June 28, 2011

PML Ref.: 10KF029

**Response to MTO Comments on
Foundation Investigation and Design Report
Blair Business Park Sanitary Sewer – Highway 401 Crossing
Cities of Cambridge and Kitchener, Ontario**

BLAIR SANITARY FORCEMAIN CROSSING
UNDER HIGHWAY 401
BOREHOLE LOCATIONS AND SOIL STRATA

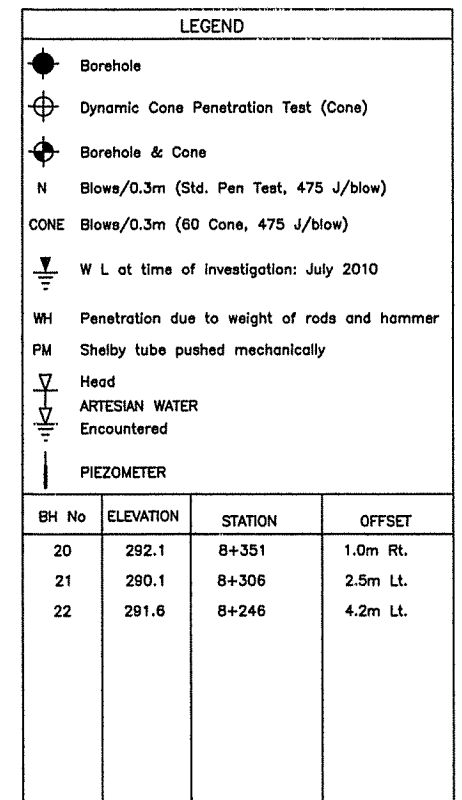
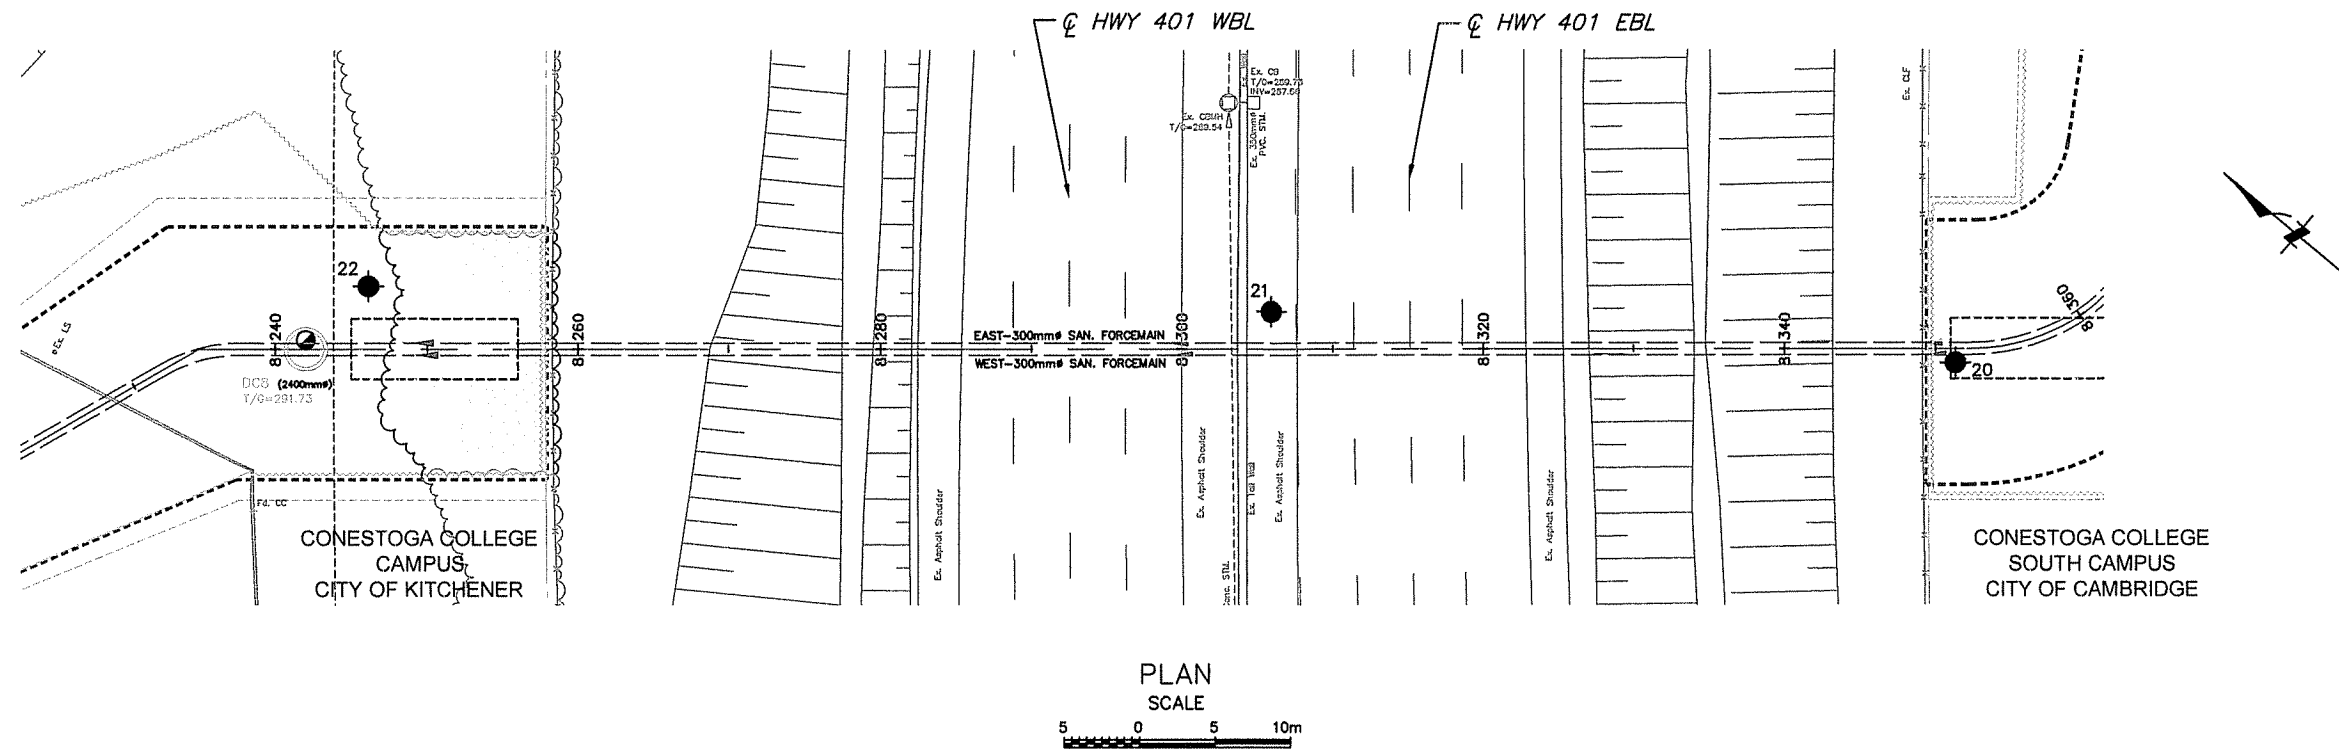
1. The MTO GEOCREC number 40P8-190 is shown on the title pages of the Final Report and on the Foundation Drawing.
2. The chainage along the sewer forcemain alignment on Drawing 1 has been changed to match the chainage on Drawing PP4.3.

DRAWING NO:
PP4.3

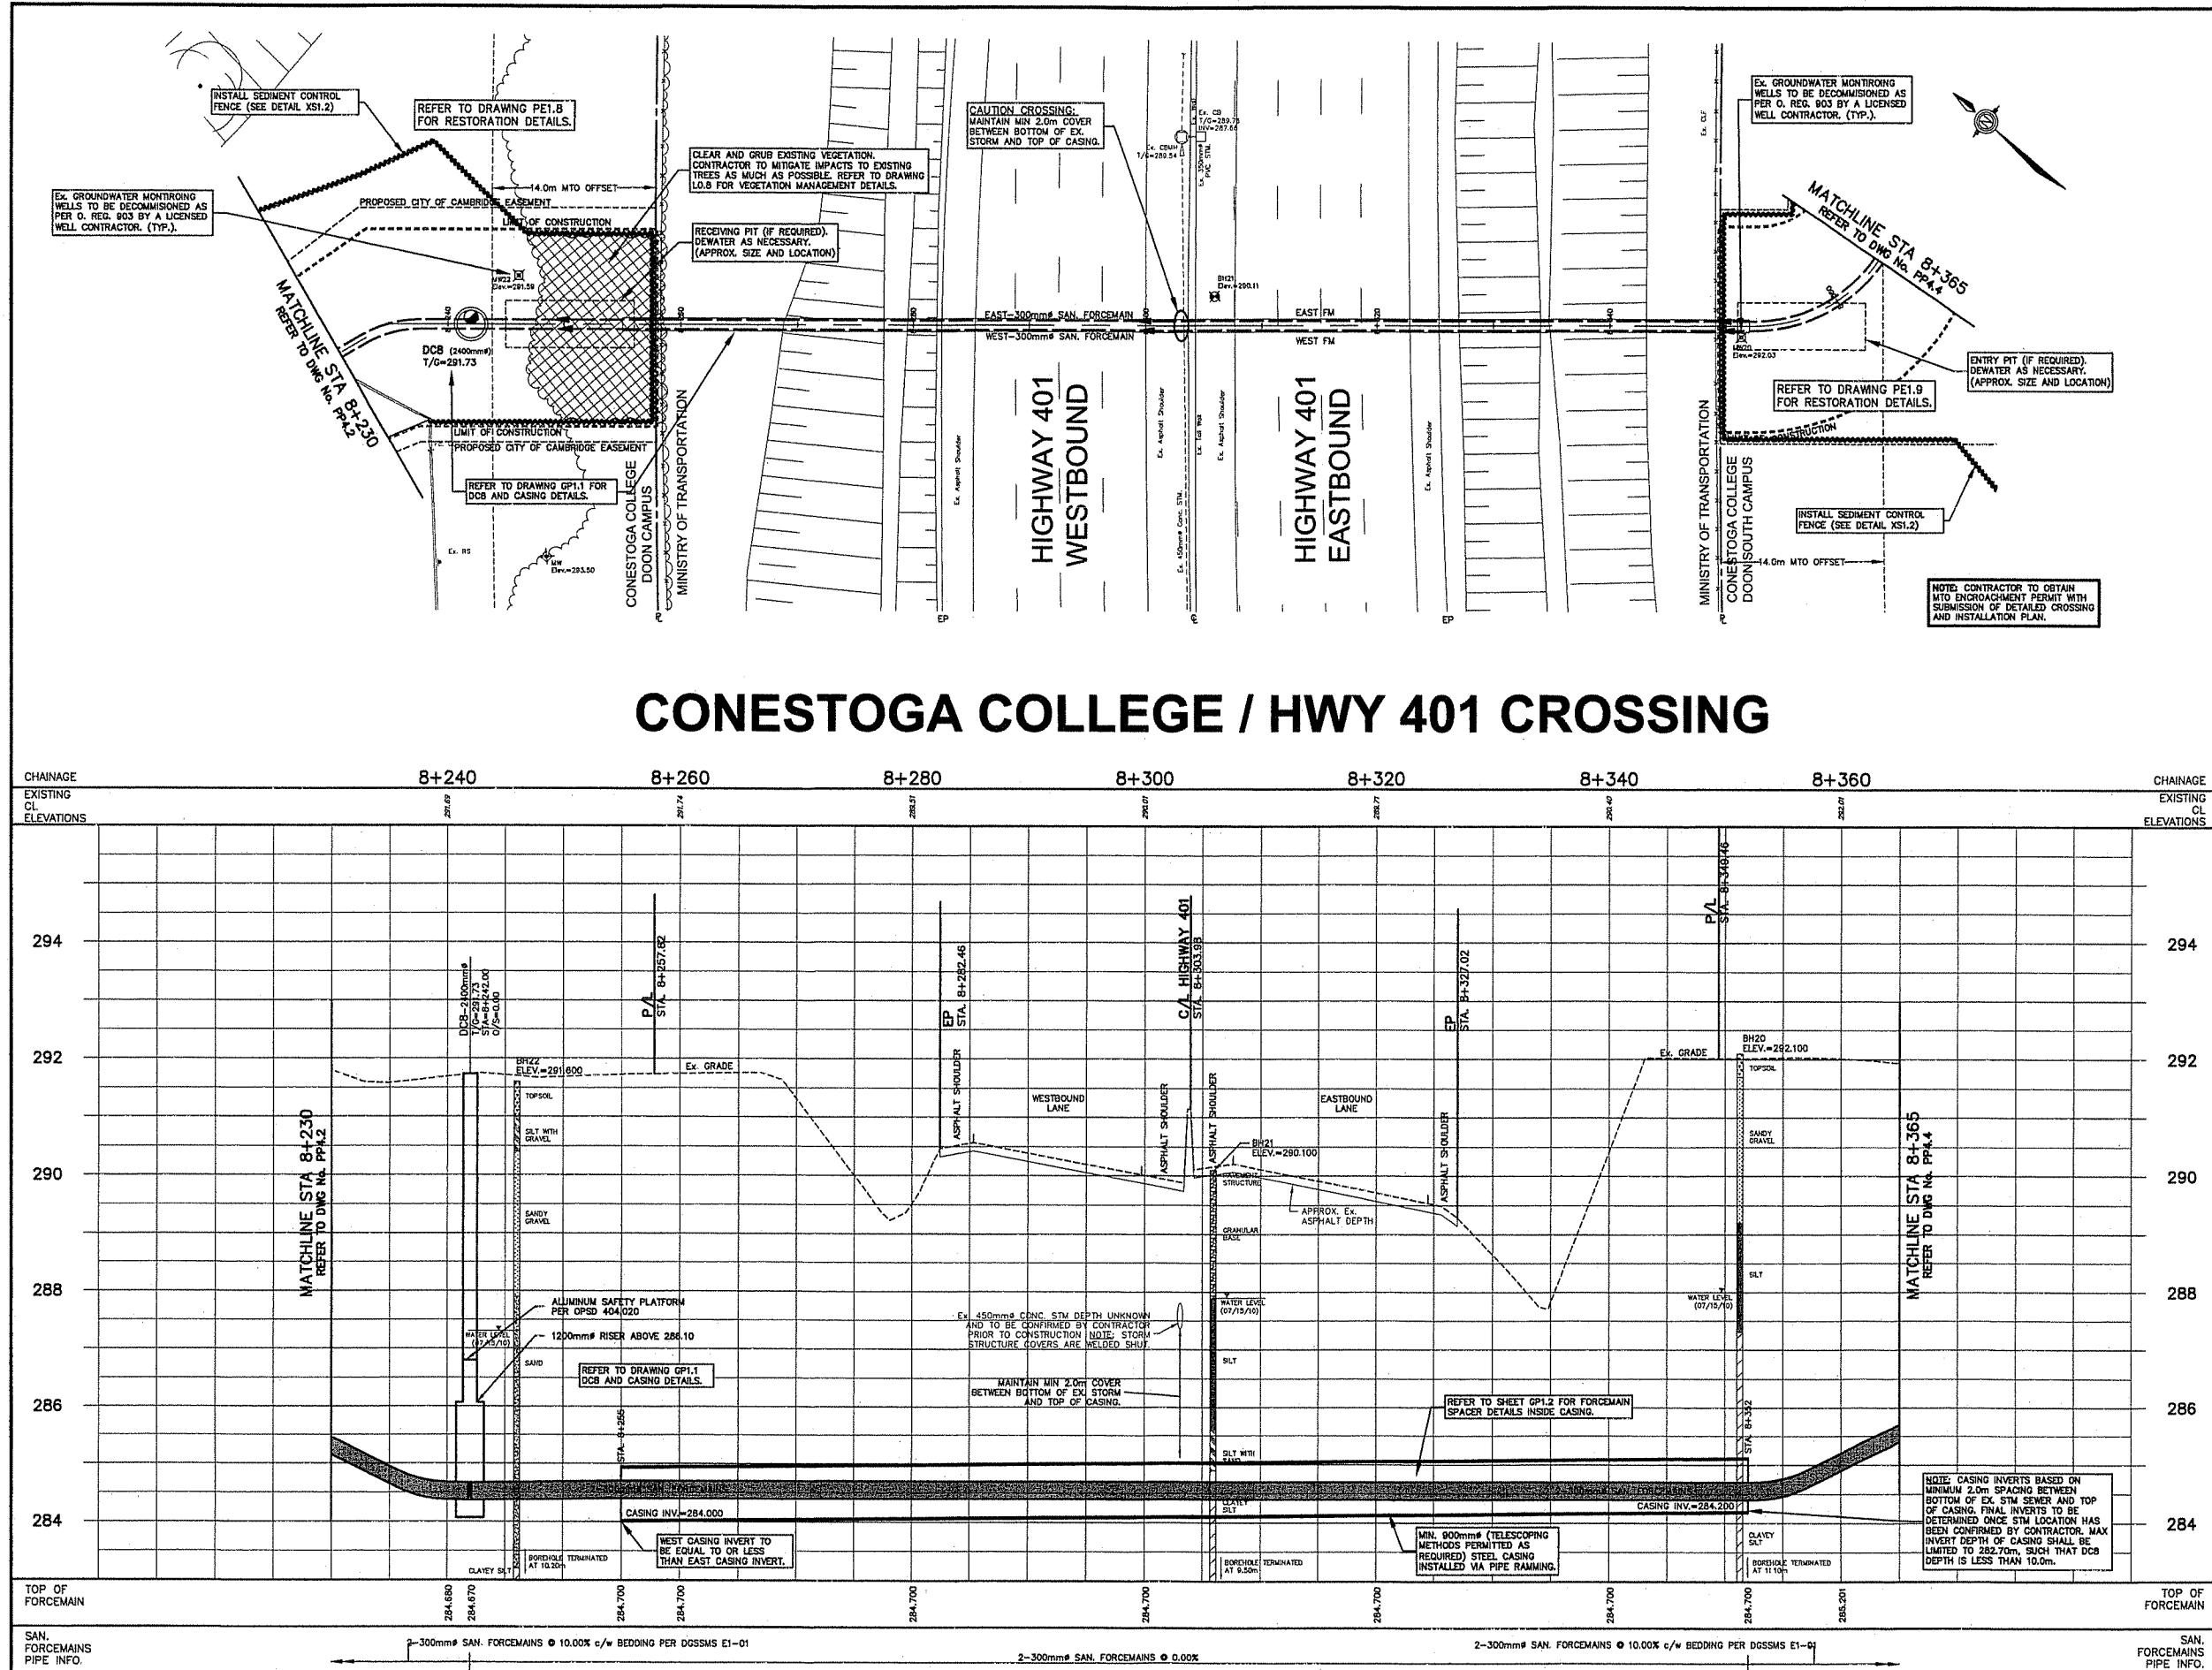
3. (a) No comment; (b) The Final Report addresses the embankment stability shown on Drawing PP4.3 between station 8+320 and 8+340.
4. (a) The Final Report addresses soil removal options within the pipe; and, (b) the potential for liquefaction of wet silty soils encountered in Boreholes 21 and 22.

In addition, care should be taken to ensure that the existing Highway 401 south ditch (between Station 8+325 and 8+345) is not undermined by the tunnelling activities. Based on the current proposed tunnelling depths (as shown on Drawing PP4.3) it is understood that the south ditch invert will be approximately 2 to 2.5 m above the casings. Based on the above, we do not anticipate any embankment stability issues for the ditch, however, we recommend that the ditch embankment be monitored during the tunnelling operations.
